# Lincoln Middle Subdivision

City of El Paso — City Plan Commission — 2/8/2018

SUSU18-00004 — Major Combination (REVISED)

**SUMMARY OF RECOMMENDATION:** Planning staff recommends **Approval** of Lincoln Middle Subdivision on a major combination basis, however, does not recommend approval of the exception request.

### Lindbergh Avenue – Section C

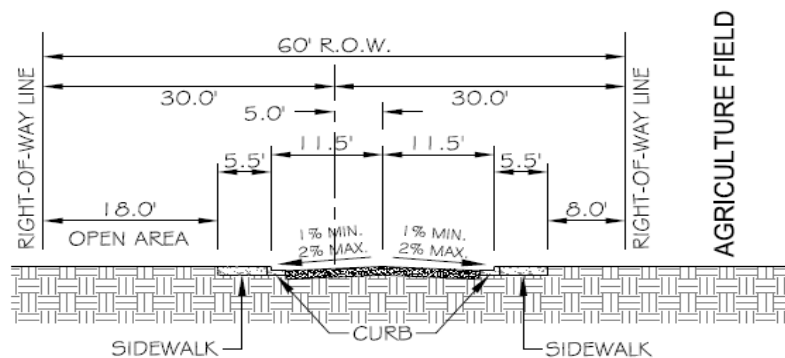
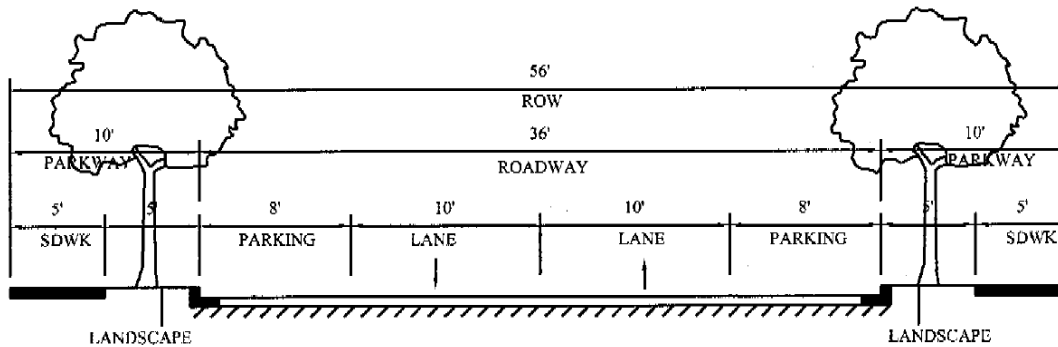
- To waive the required improvements to their proportionate share of Lindbergh Avenue, Mulberry Avenue, and Warriors Drive.
  - 1) Lindbergh Avenue – Section C  
The roadway requires 18' of participation – 16.5' is what exists. The parkway is in the wrong configuration.
  - 2) Lindbergh Avenue – Section D  
The parkway is in the wrong configuration.
  - 3) Mulberry Avenue  
The roadway requires 18' of participation – 12' is what exists. The parkway is in the wrong configuration.
  - 4) Warriors Drive – Section F  
~~Only 3' of parkway exists.~~ Only 5' of parkway exists.
- To waive 2 feet of sidewalk along a portion of Warriors Drive (Warriors – Section F)
  - 1) There is only 3 feet of sidewalk within the ROW and the DSC requires 5 feet. The remaining 2 feet is within private property.

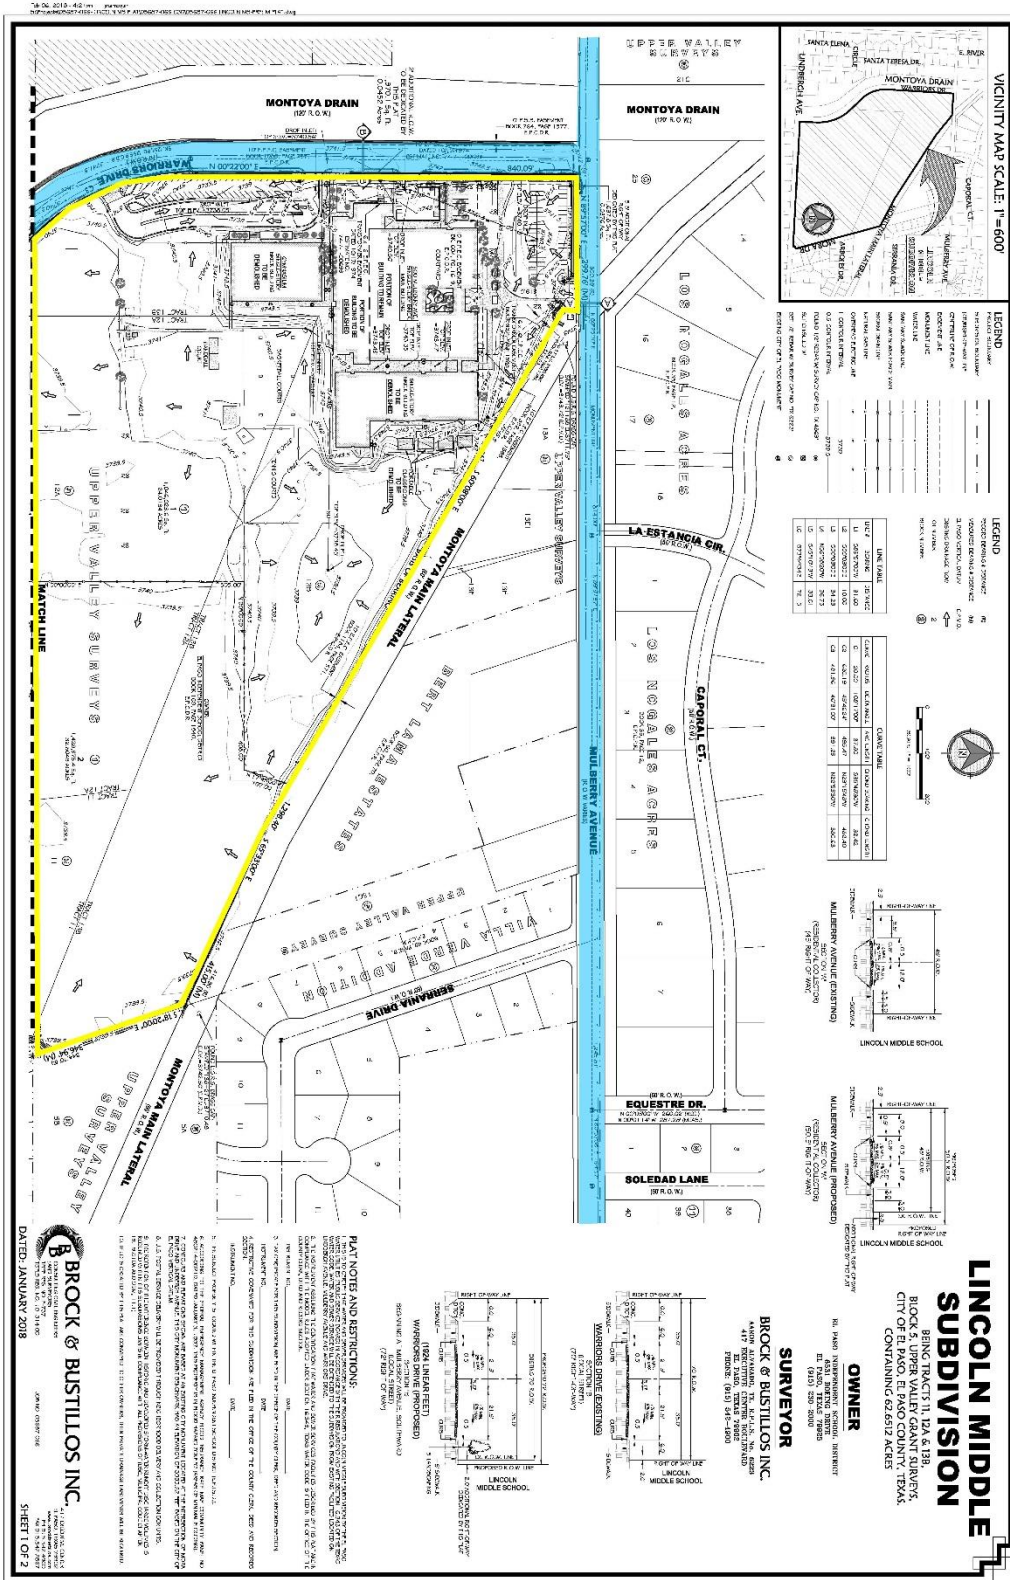
1: Verify if private drainage easements will be required between lots for storm-water runoff. Reference the document numbers on final plat if by separate instrument.

2: The proposed ponding areas shall have enough total capacity to hold the developed runoff for a designed 100-yr storm event. Verify that they are sized accordingly at time of construction.

3: Show all existing underground storm drain structures with discharge points which are connected to drop inlets shown on the preliminary plat.
